SUBJECT: Transmittal of Revised Responses to AP1000 DSER Open Items

AP1000 Design Certification Review
Draft Safety Evaluation Report Open Item Non-Proprietary Responses

DSER Open Item Number: 19.1.10.1-5 (Response Revision 1)

Original RAI Number(s): 720.009, 720.012, 720.013, 720.014, 720.017, 720.021, 720.024, 720.025

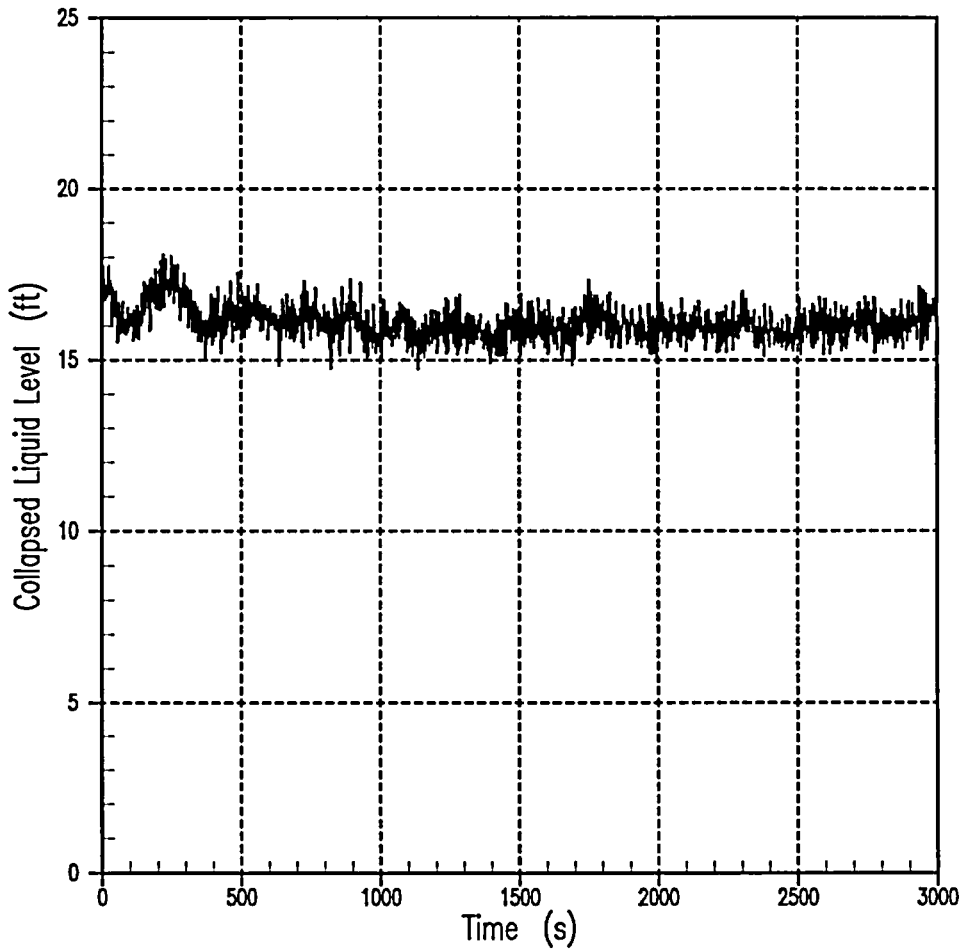
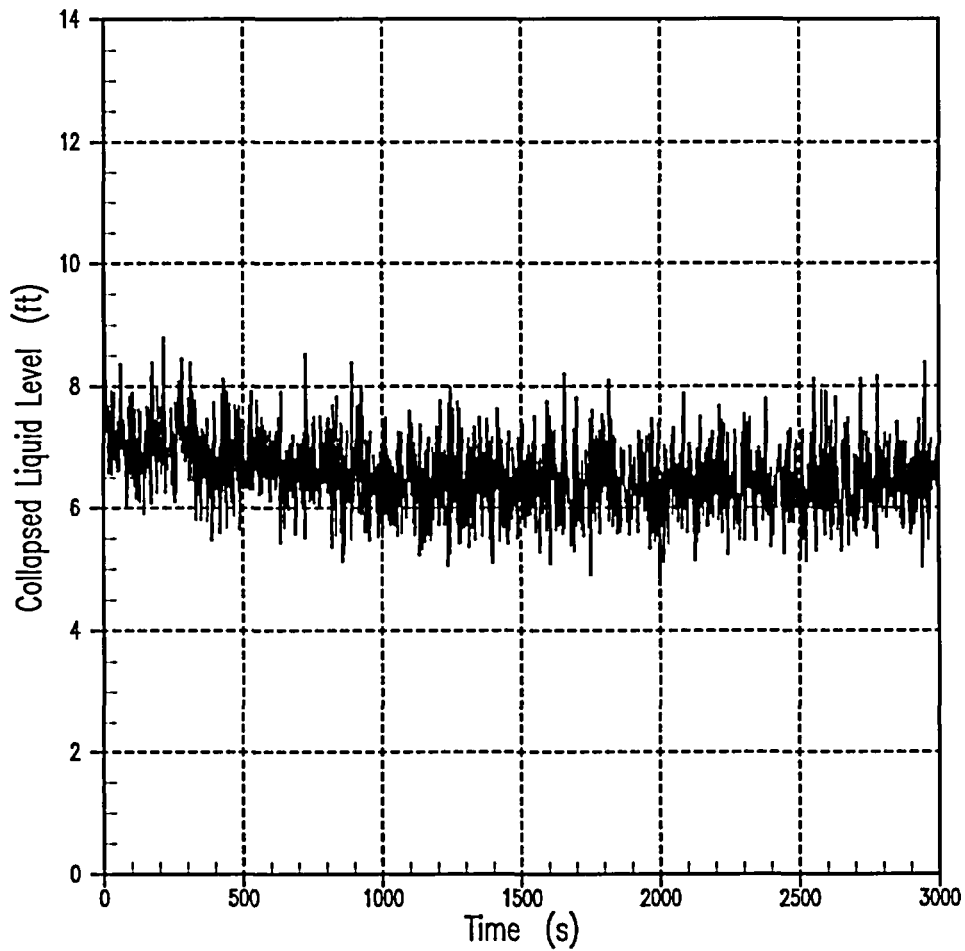
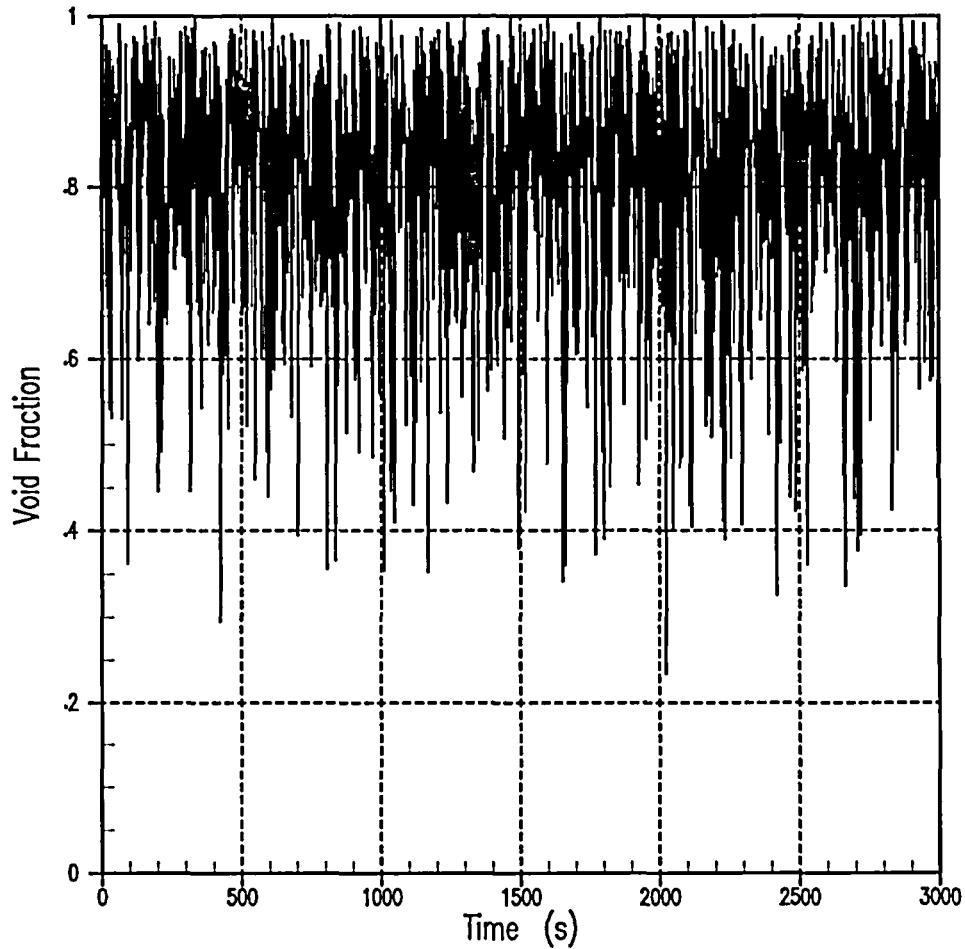
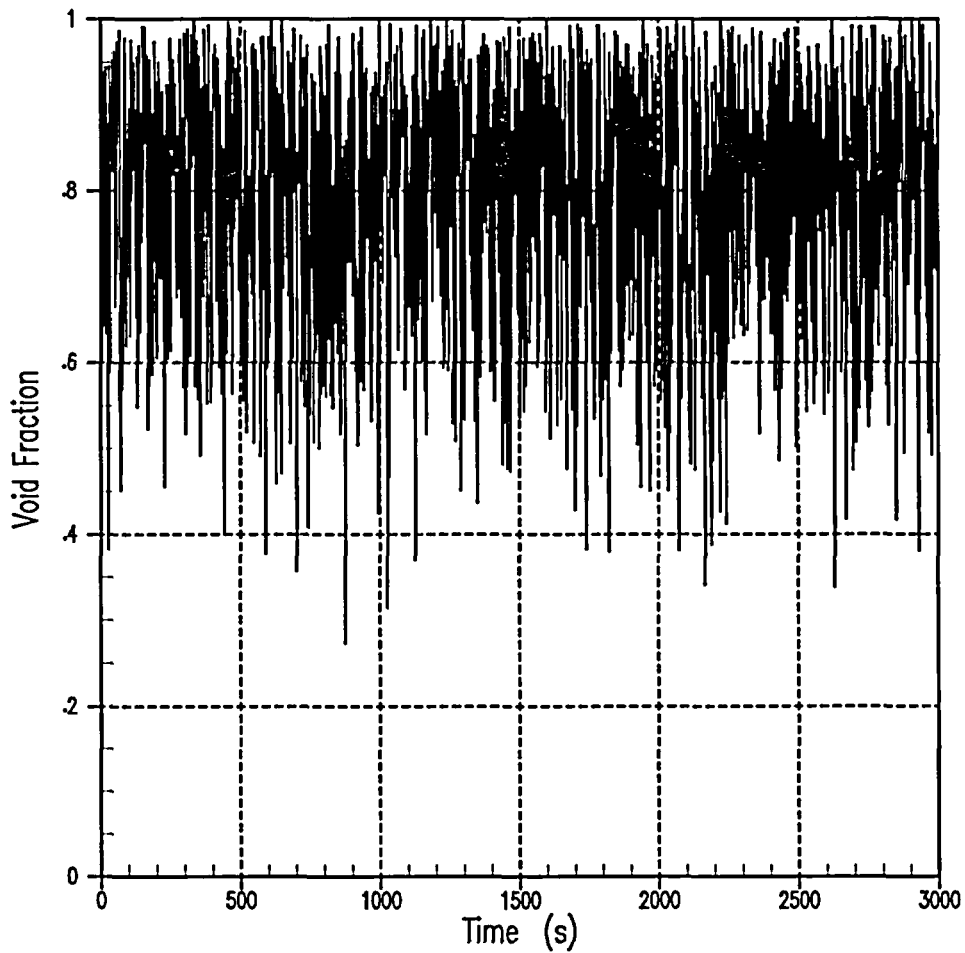
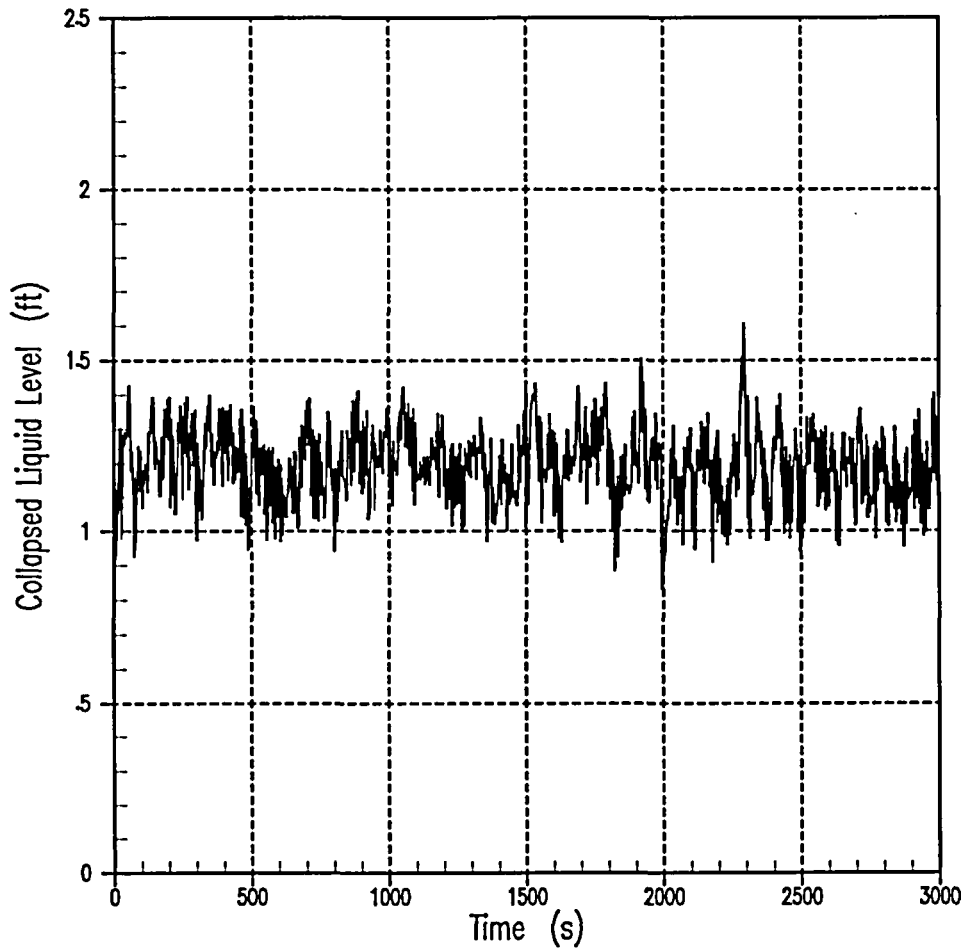
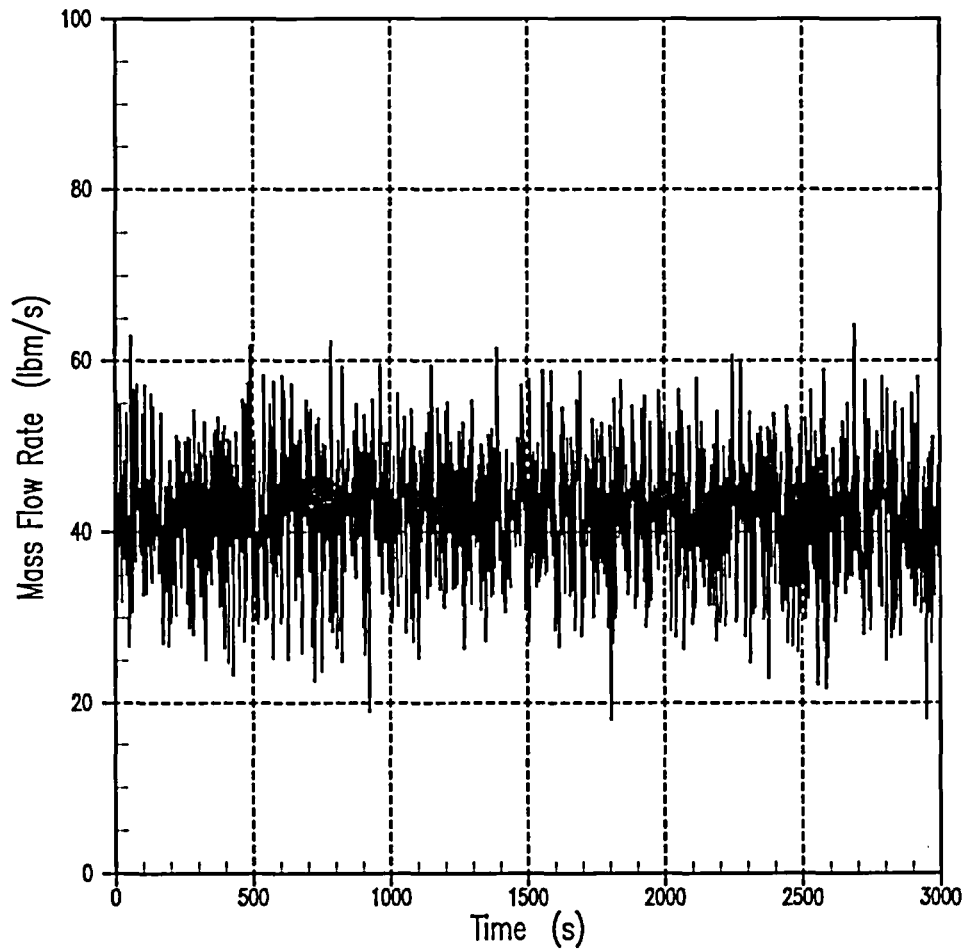
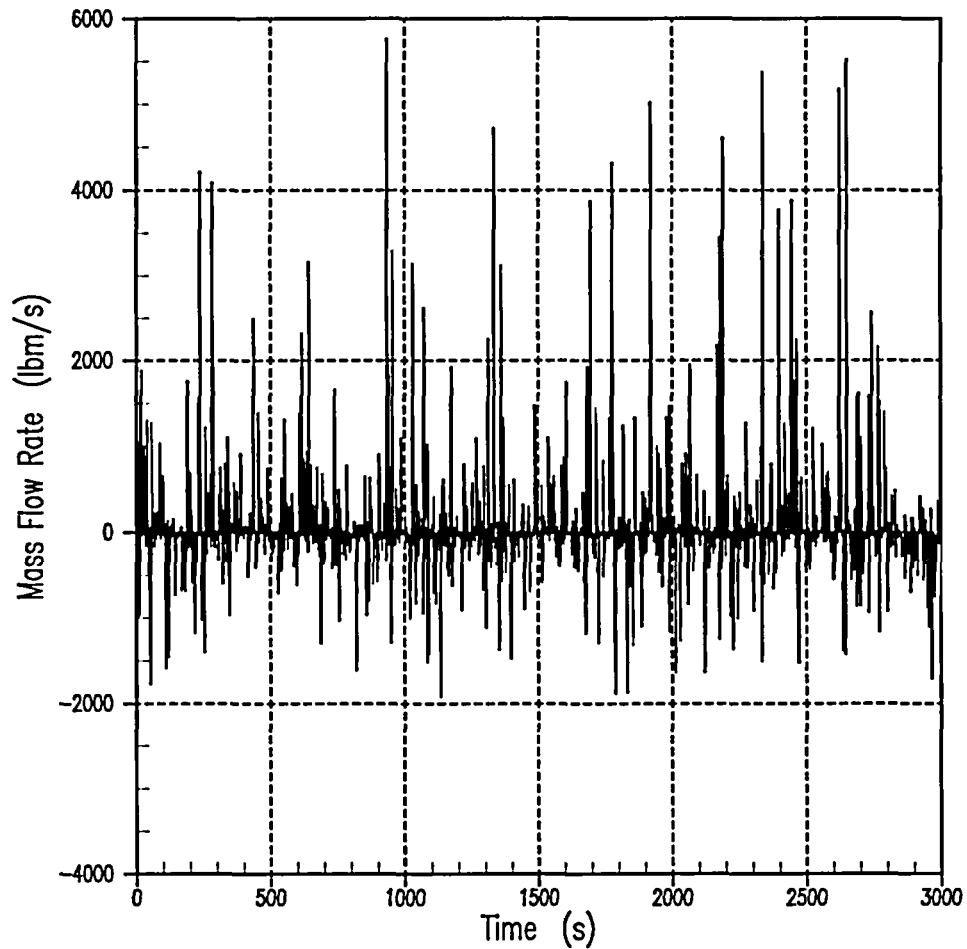
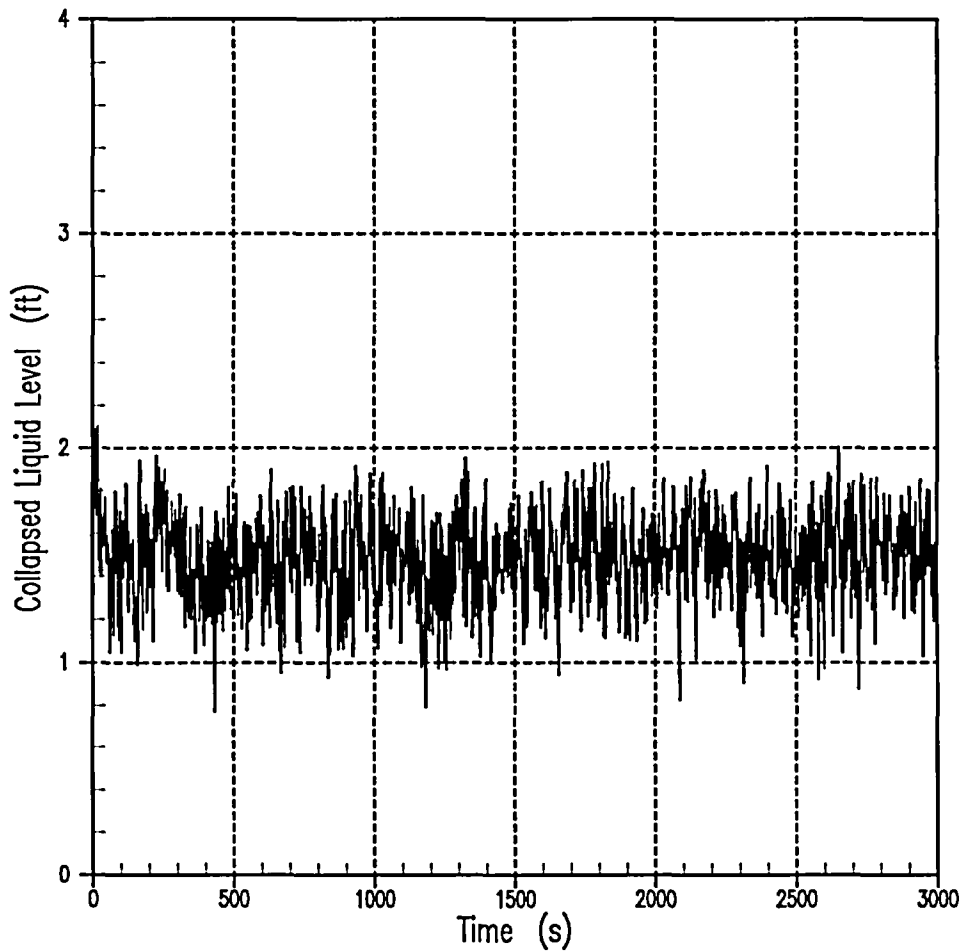
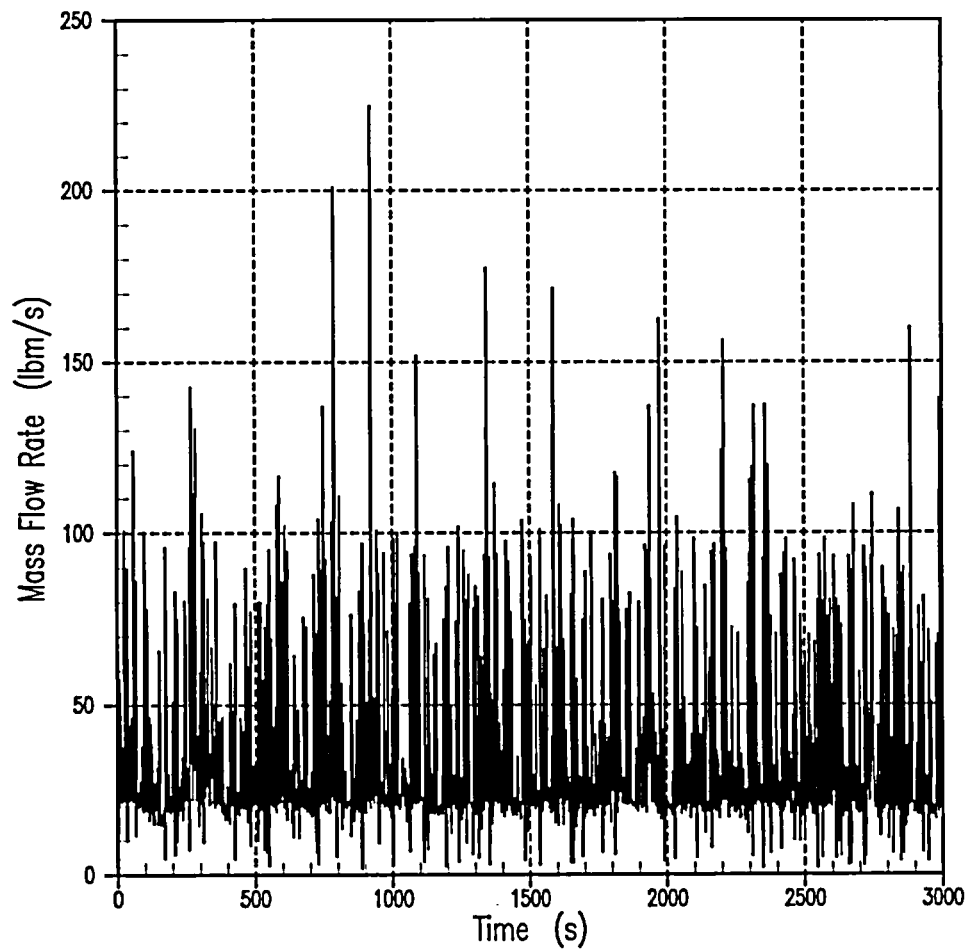
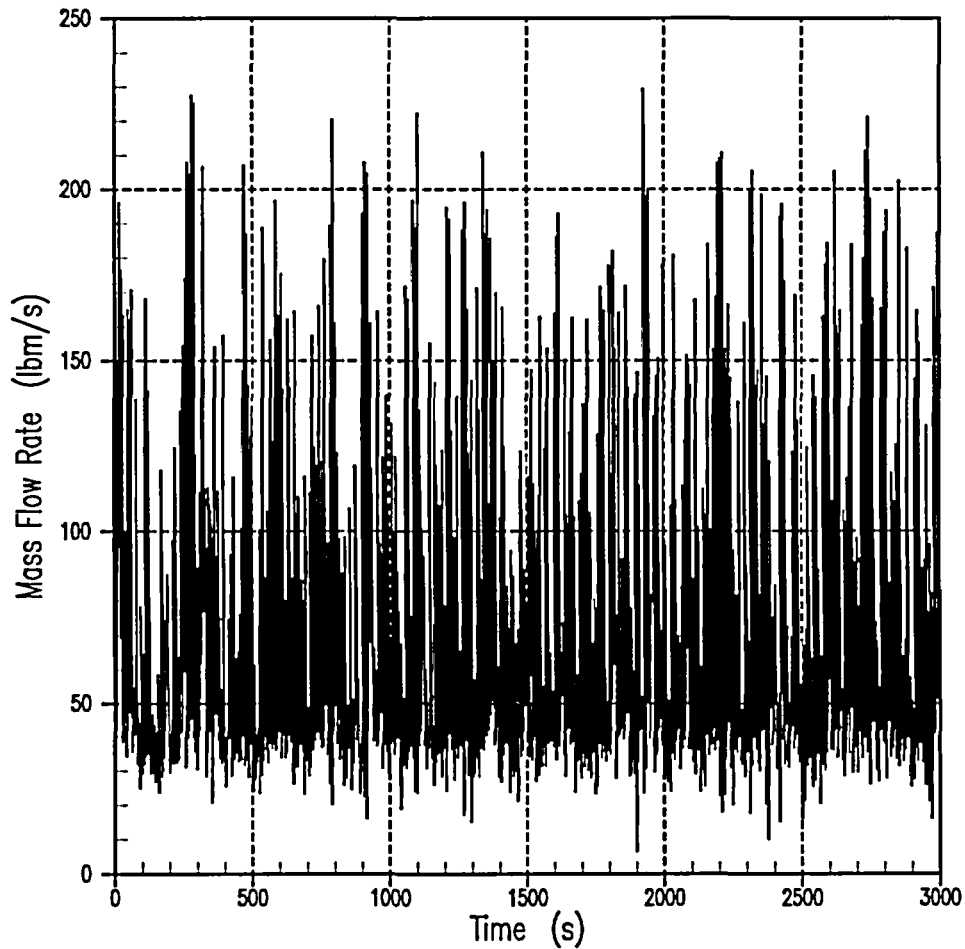
This issue remains open. In the revised response to RAI 720.013, Westinghouse performed long term cooling analyses for bounding conditions in the PRA. (Case F DEDVI, 1 CMT, 1 recirc line, 3/4 ADS4 and CI) and (Case G DEDVI, 1 CMT, 1 recirc line, 4/4 ADS4 and CI failure). The WCOBRA/TRAC code was used for LTC calculations with input conditions derived from MAAP4 analyses. As discussed in the DSER the staff has not reviewed MAAP4 except for its use in screening studies. These are analyses using minimum equipment sets as discussed in the DSER. The staff believes that only a methodology the staff has reviewed should be utilized. In addition, as a result of staff and ACRS questions, the WCOBRA/TRAC long term cooling model has been changed. The staff believes that the revised model should be used in these bounding calculations.

- (a) The long term cooling success criteria analysis case and the thermal hydraulic uncertainty cases F and G have now been performed using the revised WCOBRA/TRAC model and using input conditions from WGOETHIC. The revised cases replace the previous cases as shown below in the revision to PRA Appendix A.

Initially, the only injection comes from the IRWST into the reactor vessel through the intact DVI injection line (Figure A5.3-14). Since at the beginning of the analysis, the level in the PXS-B room is below the DVI injection nozzle elevation, only steam from the downcomer is vented out through the break (Figure A5.3-13). Water starts to flow back into the downcomer through the broken DVI line about 2 hours into the transient. This is the time when the level is at a minimum in containment, yet decay heat remains relatively high in the PXS-B room becomes high enough to provide sufficient driving head. At the onset of this event, the additional amount of water supplied into the downcomer through the DVI break supplements the IRWST injection. This leads to enhanced core cooling, and

momentarily, faster depressurization occurs at about 2.05 hours into the transient (Figure A5.3-11). Consequently, the IRWST injection is increased even further, and as a result, the levels in the downcomer (Figure A5.3-1), the reactor core (Figure A5.3-2), and the upper plenum (Figure A5.3-8) are also increased. The effect of this injection flow increase can also be seen on Figure A5.3-4, which shows a sharp void fraction decrease in the upper half of the fuel region adequate to maintain acceptable core cooling.

The available three out of four ADS Stage 4 valves provide enough venting capacity to assure adequate depressurization and successful performance of the passive safety systems (Figures A5.3-9 and A5.3-10). The fuel remains covered throughout the transient and adequate core cooling is provided to remove the decay heat. The hot rod cladding temperature at the top of the core is about 20°F above saturation (Figure A5.3-12) and is steadily decreasing exhibits no excursions.
